NO.	DATE	ISSUED FOR	BY
2	03/02/2020	ADDENDUM	GAB
1	01/21/2020	BID SET	GAB

CITY OF HALLANDALE BEACH UTILITIES DEPARTMENT
PRODUCTION WELL PW-9
STAGING PLAN

Proposing firms must provide this Addendum # 2 form signed by an authorized officer of the firm to acknowledge receipt of ADDENDUM # 2. The form must be provided with firm's response.

DATE: FEBRUARY 2020
SHEET: 5 OF 42
DRAWING: C-02

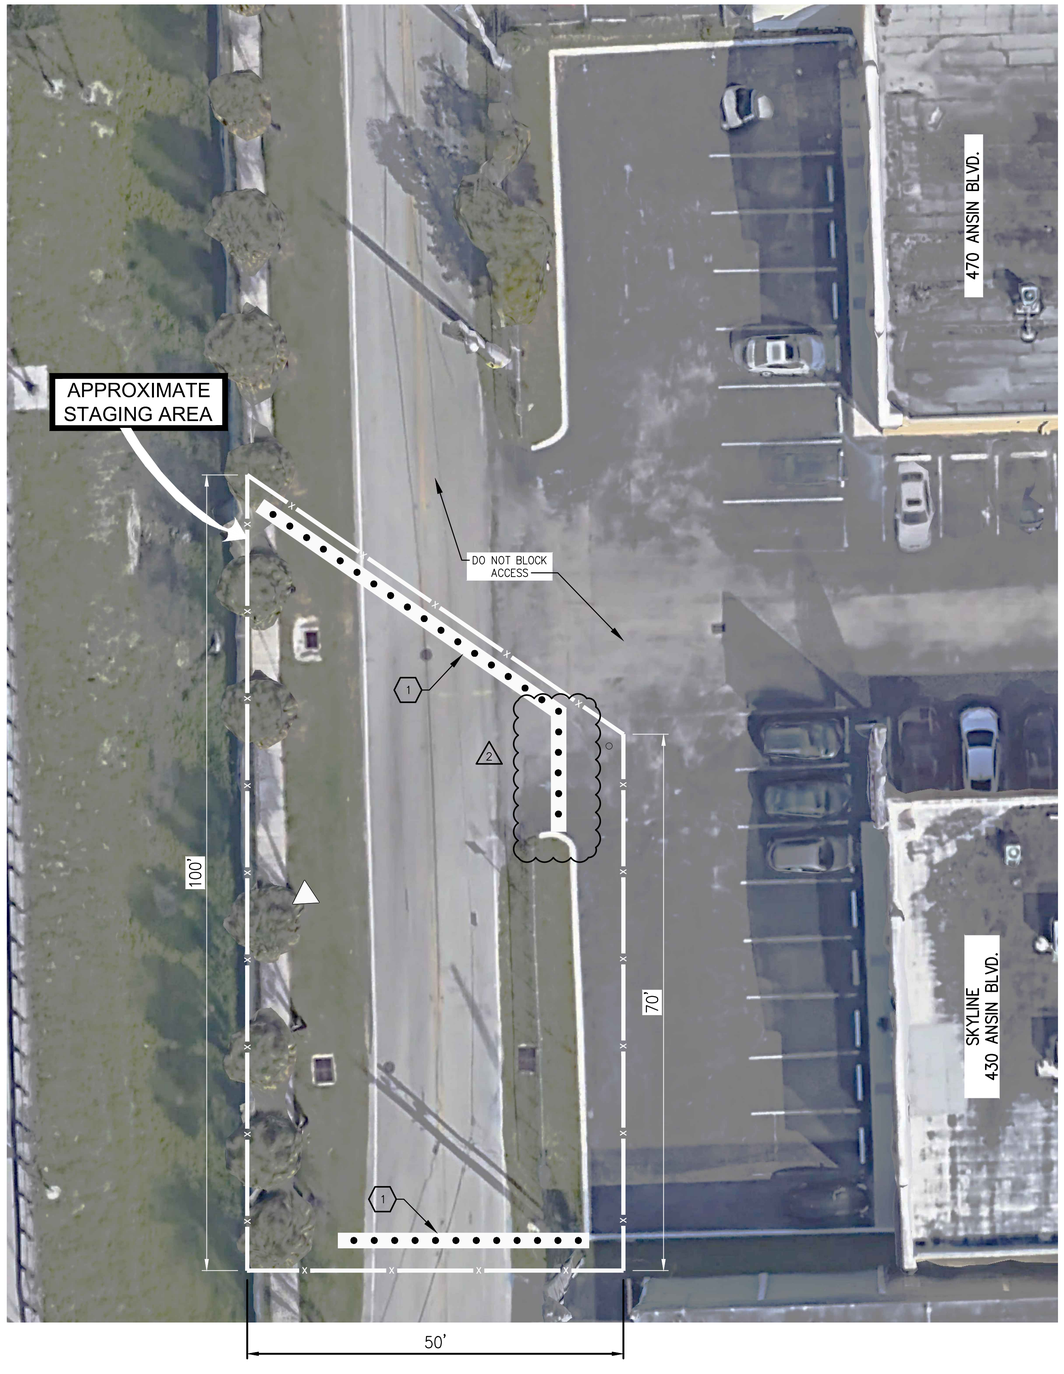
QUESTION #8.
Can the MOT barriers, etc. be left in place continuously or do they have to be removed at the end of each work day and put back up the following day?

1. IT IS THE ENGINEER-OF-RECORD'S DESIGN INTENT THAT THE TRAFFIC BARRIERS SHOWN ON THIS DRAWING BE LEFT IN PLACE CONTINUOUSLY DURING THE WELL DRILLING PHASE AND OTHER CONSTRUCTION PHASES AS DEEMED NECESSARY BY THE CONTRACTOR.

2. LEAVING THE BARRIERS IN PLACE FOR AN EXTENDED DURATION WILL RESULT IN CLOSING THE ROAD (AND SIDEWALK) IN THE VICINITY OF THE CONSTRUCTION SITE FROM VEHICLE AND PEDESTRIAN TRAFFIC.

3. THE CONTRACTOR SHALL SUBMIT A TRAFFIC CONTROL PLAN TO THE CITY OF HALLANDALE BEACH ENGINEERING DIVISION IN ACCORDANCE WITH TECHNICAL SPECIFICATION 01570.

4. THE CONTRACTOR'S TRAFFIC CONTROL PLAN SHALL REQUEST PERMISSION TO LEAVE THE TRAFFIC BARRIERS IN PLACE FOR AN EXTENDED DURATION.
5. THE TRAFFIC CONTROL PLAN SHALL DEFINE DETOUR REQUIREMENTS (SEE TECHNICAL SPECIFICATION 01570) TO ENSURE THAT VEHICLES AND PEDESTRIANS CAN REACH BUSINESSES ON EITHER SIDE OF THE REQUESTED TEMPORARY ROAD CLOSURE.

ANSWER #8.
See "Maintenance of Traffic Notes" added to revised Drawing C-02 issued with this Addendum.

DATE: FEBRUARY 2020
SHEET: 6 OF 42
DRAWING: C-03

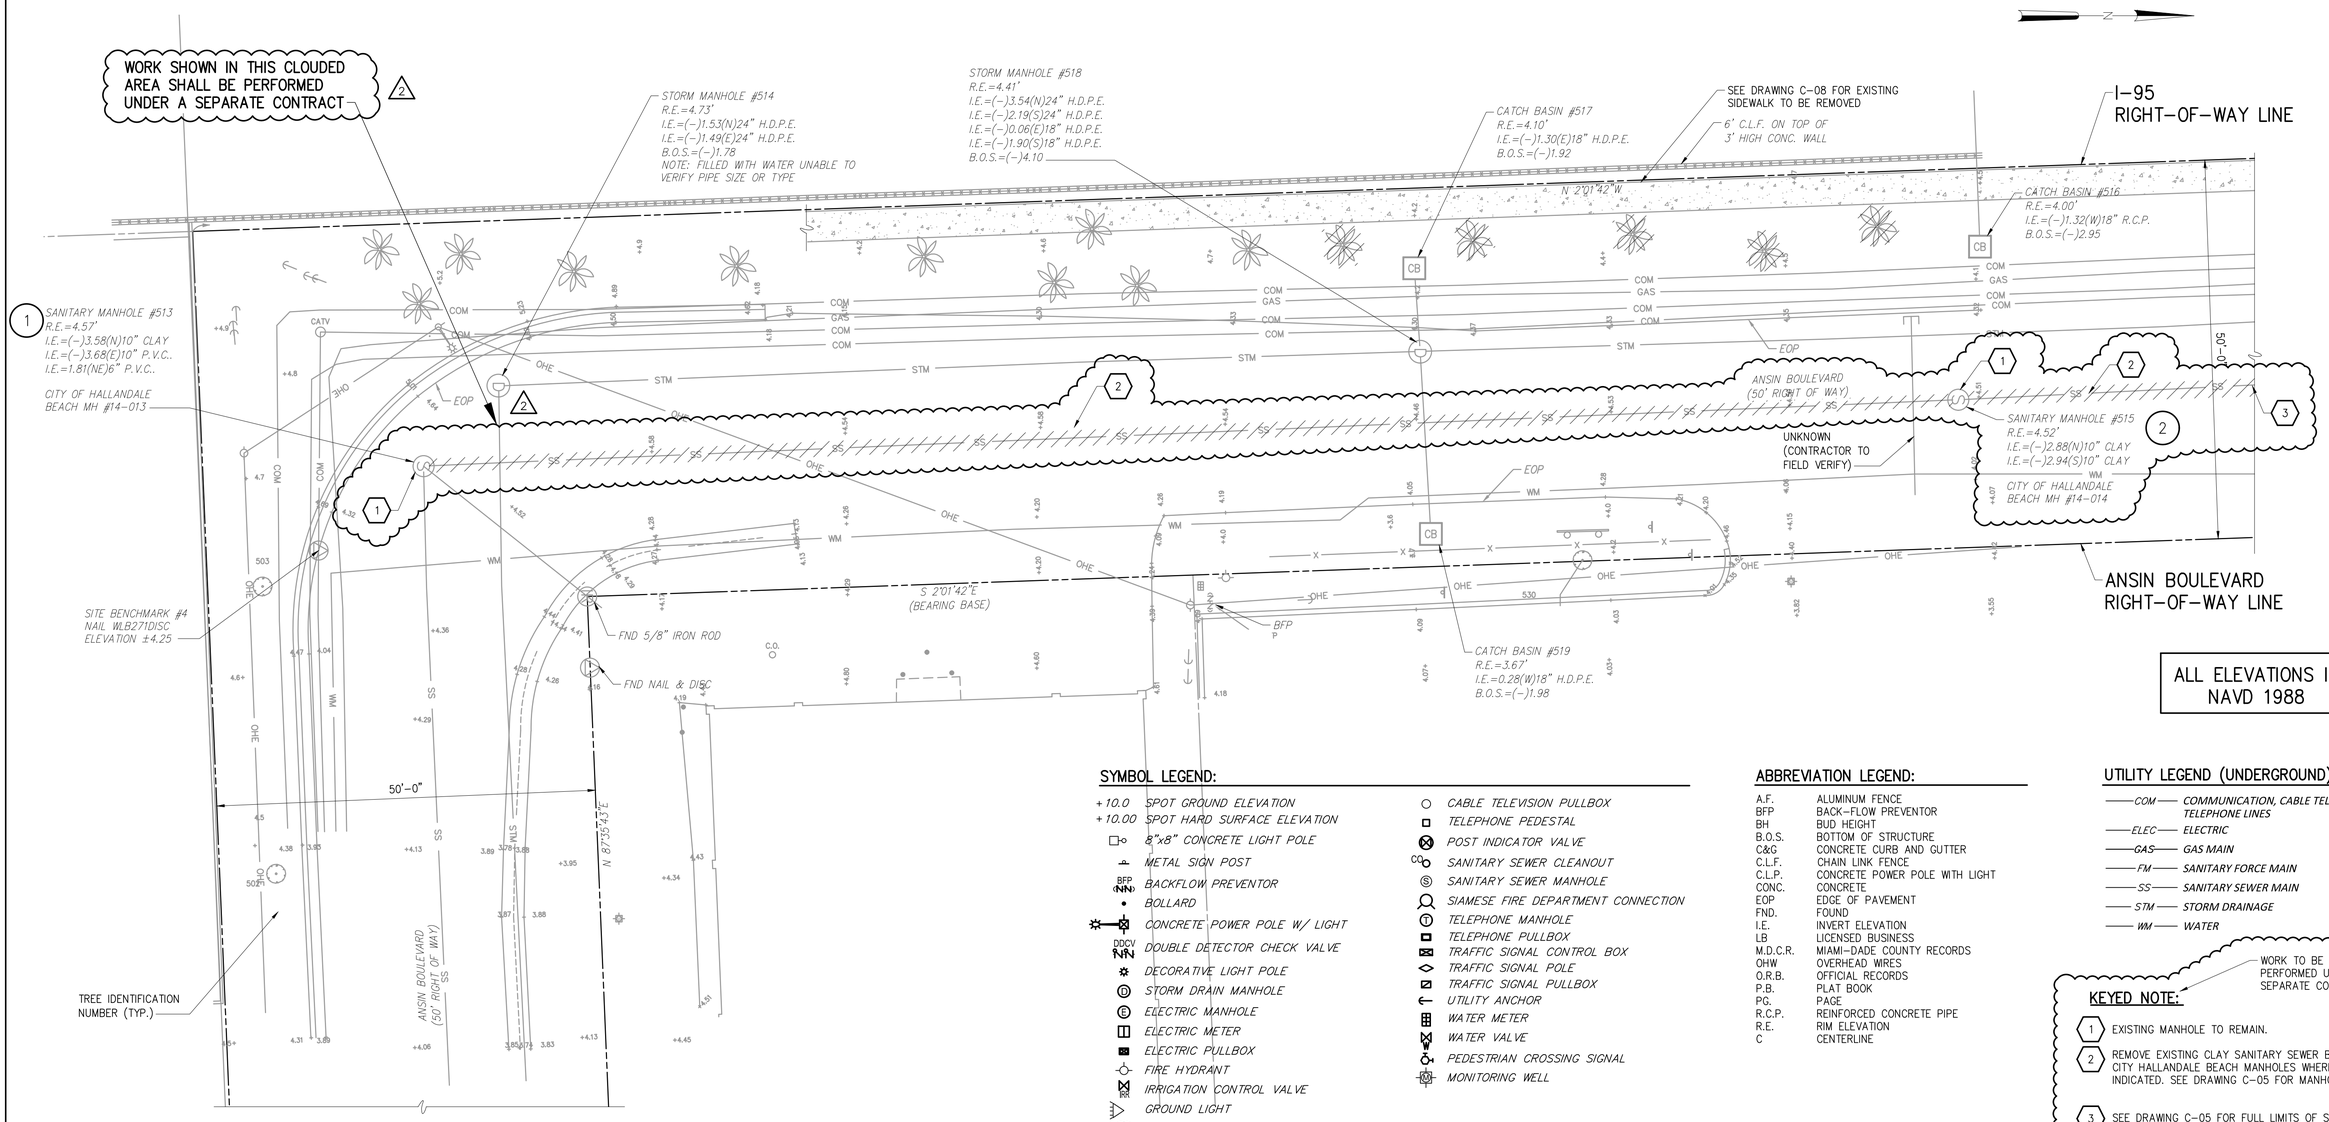
QUESTION #11.
Is any bypass pumping required for the sanitary sewer pipe replacement?

ANSWER # 11
See revised drawings C-03, C-04, C-05, C-06 and C-07 issued with this addendum.

DATE: FEBRUARY 2020
SHEET: 8 OF 42
DRAWING: C–05

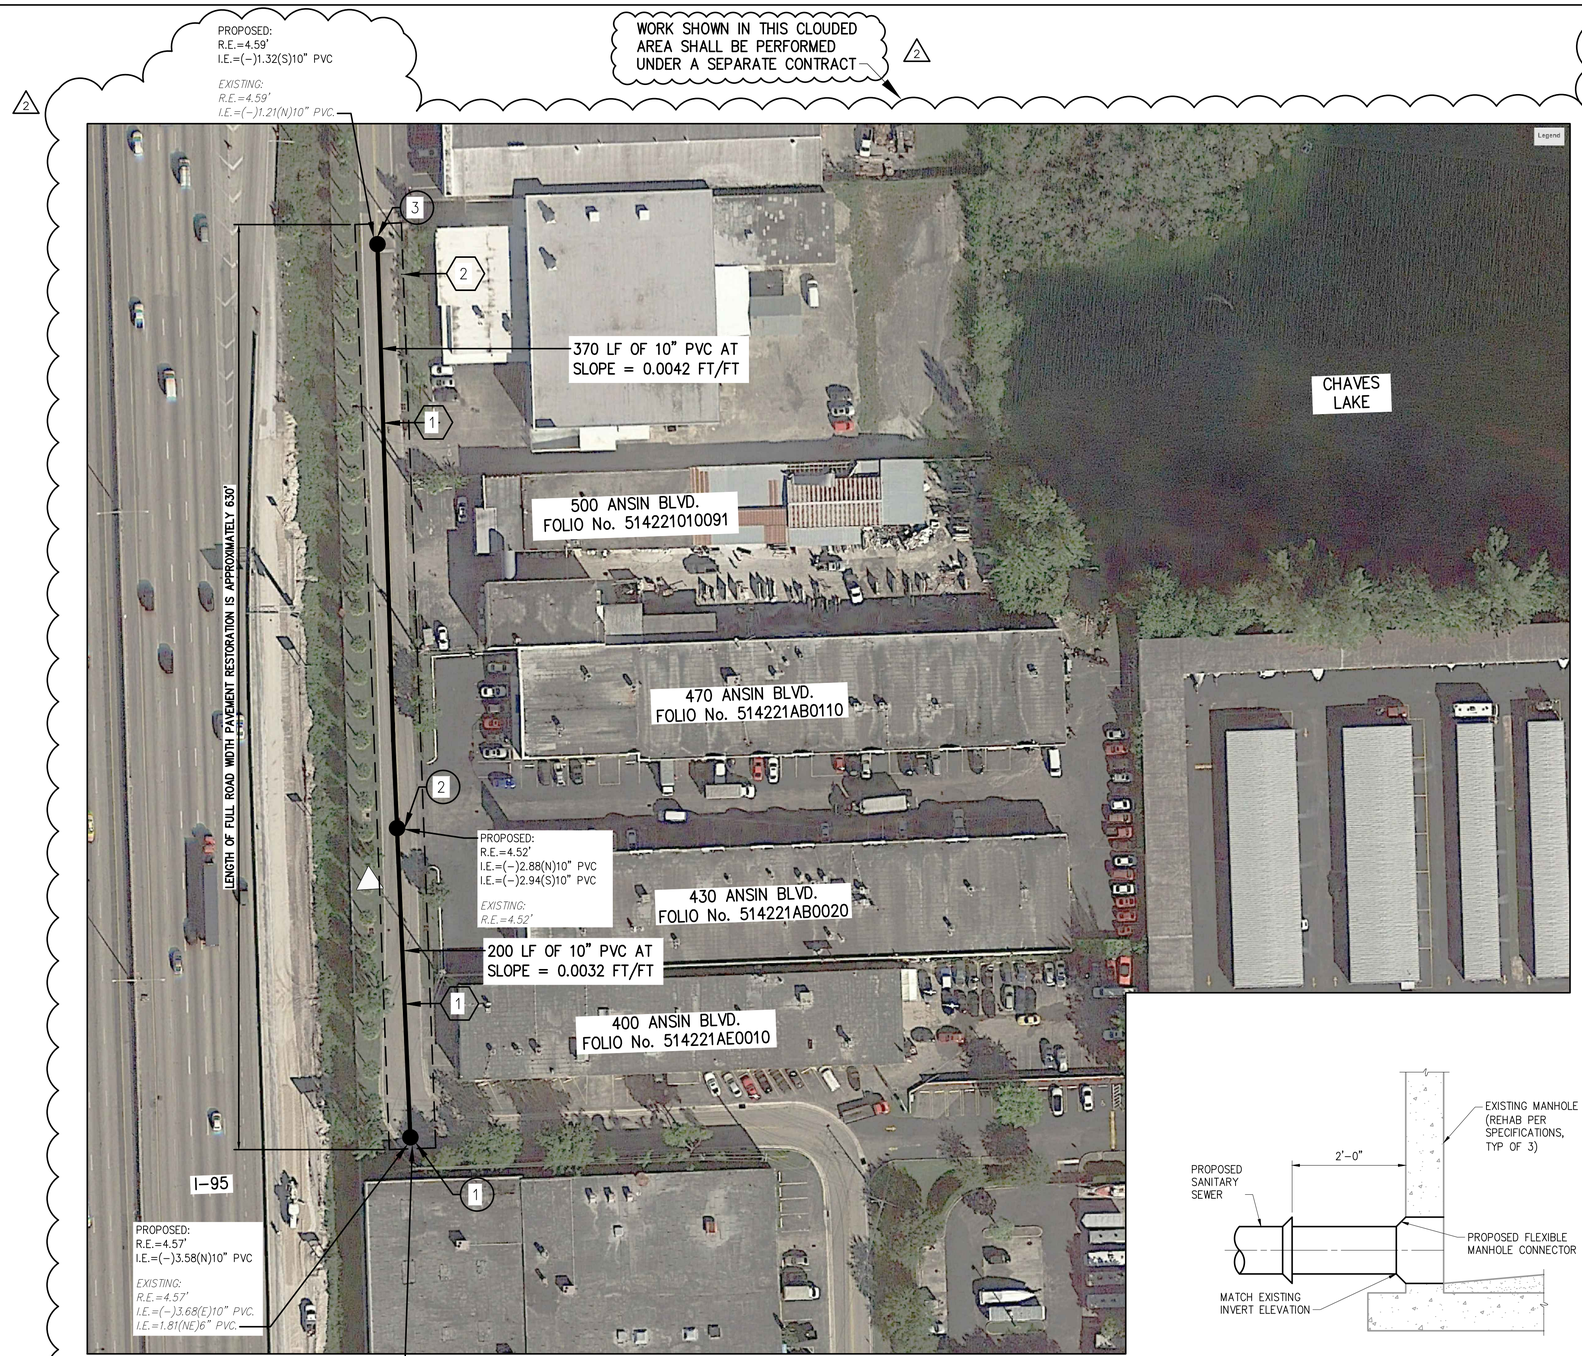
QUESTION #14.
General note 3 on dwg C-05 calls for 150 PSI pressure testing of sanitary sewer pipe. This is an unusual requirement. Please confirm that this note is correct.

1. REMOVE THE EXISTING GRAVITY SANITARY SEWER PIPE (ASSUMED TO BE 10" DIAMETER CLAY) AND REPLACE WITH PVC PIPE THAT CONFORMS TO THE FOLLOWING:
   A. COMPLY WITH AWWA C900
   B. PRESSURE CLASS 165; DR=25
   C. TEST PIPE FOLLOWING INSTALLATION (BUT PRIOR TO FINAL CONNECTION WITH THE MANHOLES) TO 150 PSI TEST PRESSURE
   D. MATCH DIAMETER AND SLOPE OF THE EXISTING PIPE BEING REPLACED. FOR THE PURPOSE OF BIDDING ASSUME THAT THE REPLACEMENT PIPE WILL BE 10" DIAMETER.
2. RESTORE PAVEMENT FOR FULL ROAD WIDTH AS INDICATED IN THE CIVIL DETAILS.

ANSWER # 14.
See revised drawings C-03, C-04, C-05, C-06 and C-07 issued with this addendum.

DATE: FEBRUARY 2020
SHEET: 10 OF 42
DRAWING: C-07

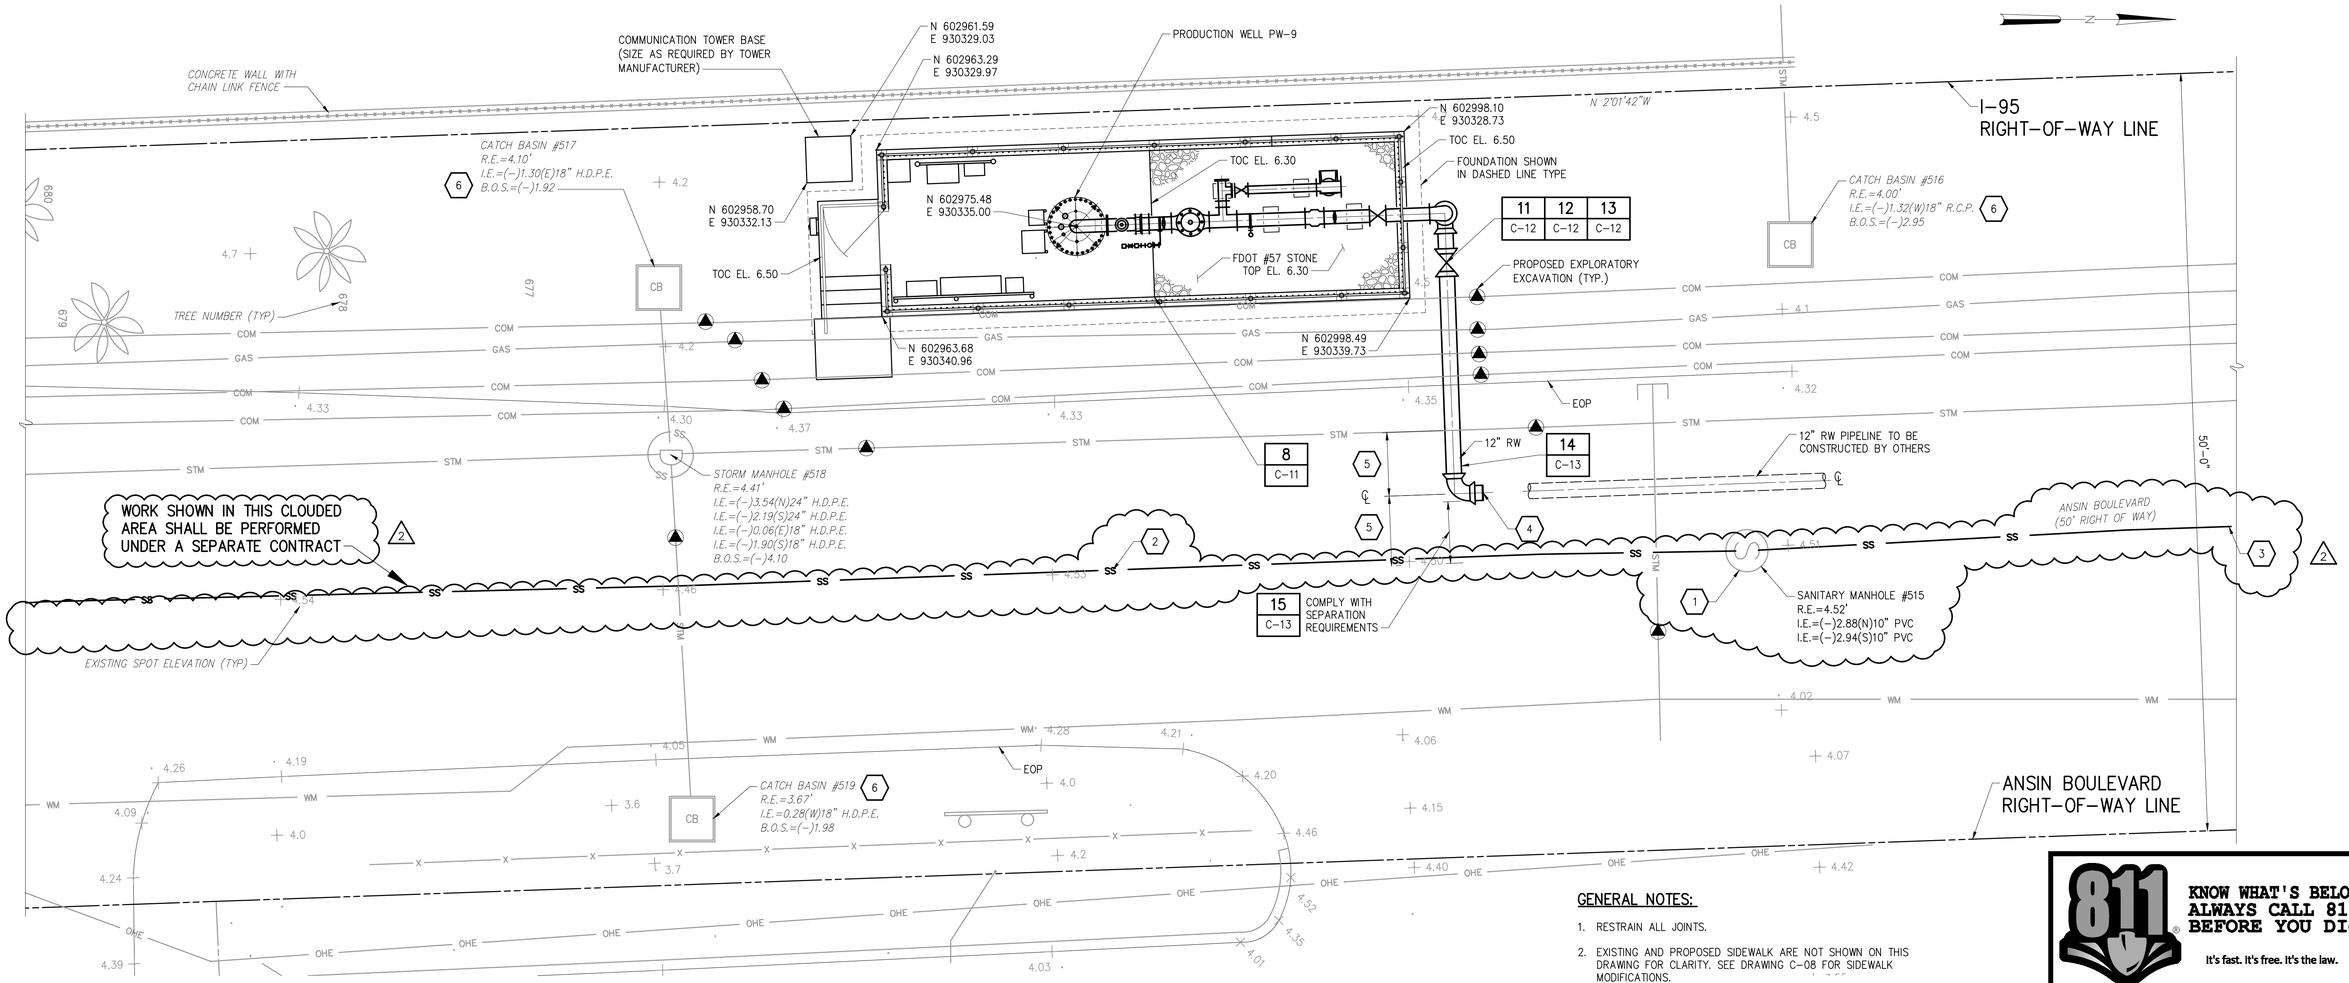
QUESTION #10.
Dwg C-07 keyed note 1 refers to manhole rehabilitation specifications. There do not appear to be any manhole rehab specs included in the bid docs. Please advise.

1. EXISTING MANHOLE TO REMAIN. REHAB MANHOLE PER SPECIFICATIONS.
2. REPLACE EXISTING SANITARY SEWER.
3. SEE DRAWING C-05 FOR FULL LIMITS OF SANITARY SEWER REPLACEMENT.
4. MECHANICAL JOINT PLUG RESTRAINED WITH MEGA-LUG SHOWN. CONTRACTOR SHALL REMOVE PLUG AND MAKE FINAL CONNECTION WITH THE 10-INCH RAW WATER PIPELINE CONSTRUCTED BY OTHERS. FURNISH AND INSTALL A SOLID SLEEVE COUPLING, A MINIMUM OF 10-FEET OF 10-INCH RAW WATER PIPE AND RESTRAINING DEVICES FOR ALL JOINTS.
5. CENTER THE PROPOSED 10-INCH RAW WATER PIPE BETWEEN THE EXISTING STORM DRAINAGE PIPE AND THE PROPOSED SANITARY SEWER.
6. PROTECT ALL CATCH BASINS WITH STRAW BALE SEDIMENT FILTERS. AT COMPLETION OF CONSTRUCTION REMOVE ALL DEBRIS AND SEDIMENTS FROM THE CATCH BASIN STRUCTURES.

ANSWER # 10.
See revised drawings C-03, C-04, C-05, C-06 and C-07 issued with this addendum.

DATE: FEBRUARY 2020
SHEET: 13 OF 42
DRAWING: C-10

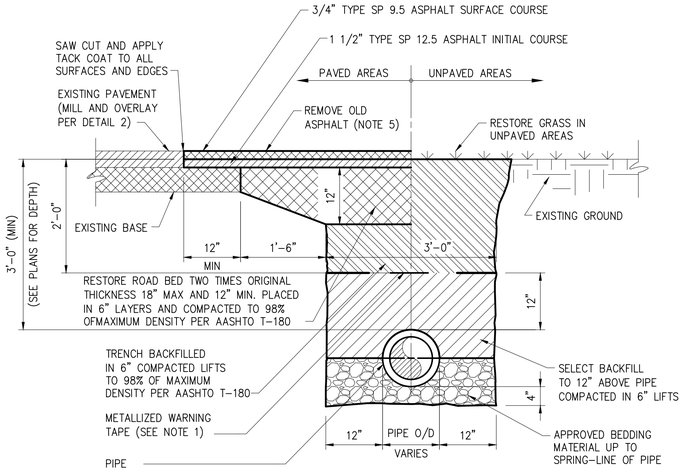
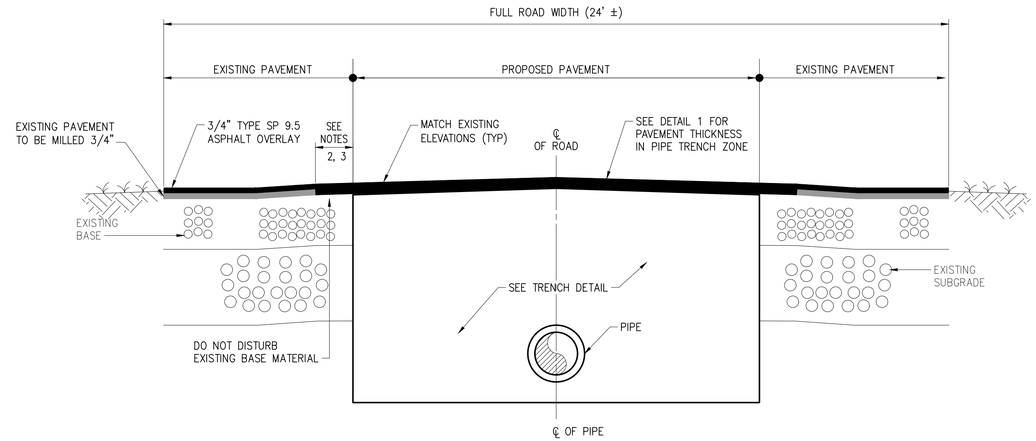
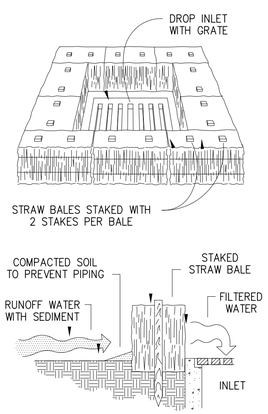
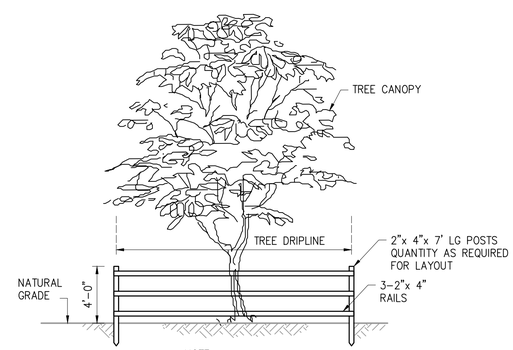
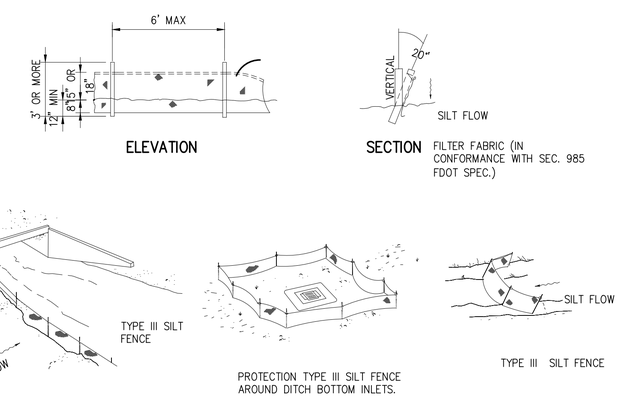
QUESTION #13.
Detail 3/C-10 is for bollards but I cannot locate any bollards required on the plans.

ANSWER # 13.
See revised drawing C-10 issued with this addendum.
